## DESCRIPTION OF DIFFERENCES

between ORIGINAL and SIMILARITY

Name of Appliance : Cordless Telephone System  
 SIMILARITY Model No. : KX-TG9321 (Base Unit)  
 FCC ID : ACJ96NKX-TG9321  
 ORIGINAL Model No. : KX-TG9391 (Base Unit)  
 FCC ID : ACJ96NKX-TG9391  
 Approval Date : June 5, 2008

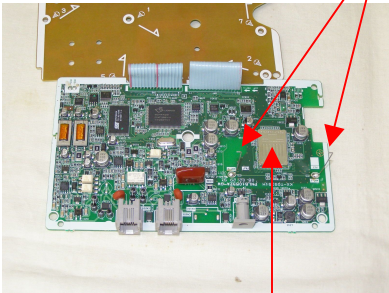
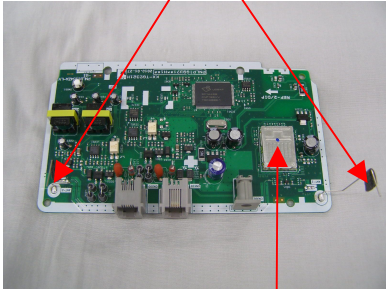
ORIGINAL KX-TG9391	NEW KX-TG9321
<b>RF Type and Appearance</b>	1.9GHz US-DECT  	1.9GHz US-DECT  
<b>P.C. Board</b>	 <p style="color: red; text-align: center;">1.9GHz Antennas are different.</p> <p style="color: red; text-align: center;">RF Unit (1.9GHz Portion)</p>	 <p style="color: red; text-align: center;">RF Unit (1.9GHz Portion)</p> <p style="color: red; text-align: center;">Same 1.9GHz RF Unit</p>
NOTE: The 1.9GHz RF unit of KX-TG9321 is identical to that of KX-TG9391 except for antenna.
